From: Kock, Andrea
Sent: Wednesday, September 30, 2009 2:01 AM
To: Fetter, Allen
Cc: Bjornsen, Alan; Park, James
Subject: Comments on hydrology sections of Lost creek SEIS

3.5.2 Wetlands

3.5.3 Groundwater

Figure 3-6: Site Hydrostratigraphic Units - Source: Modified from LCI Figure 3.5-10. Lost Creek ISR Project. U.S. NRC Source Material License Application, Environmental Report, October 2007 (Revised March 2008).

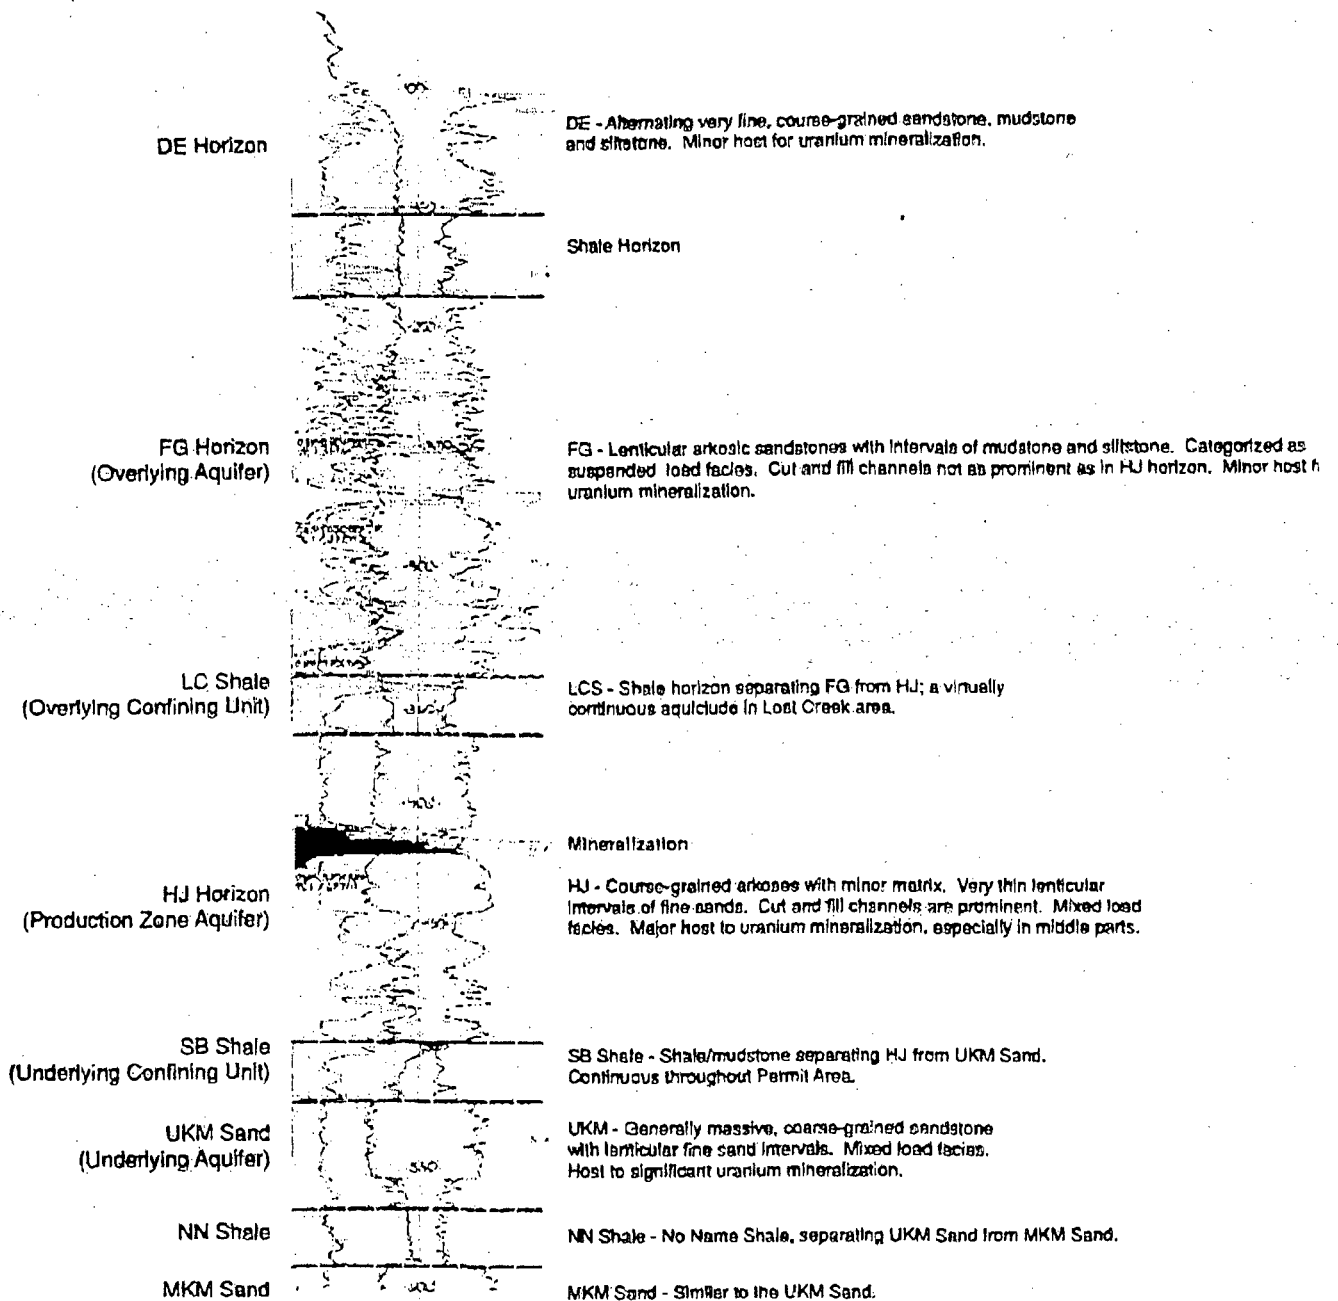
San Juan
Basin
Dolan
Fault
Sublette
County
Wasatch
Fault
Mesa Verde
Aquifer
Lewis Shale
Aquitard
Permo-Triassic
confining
units
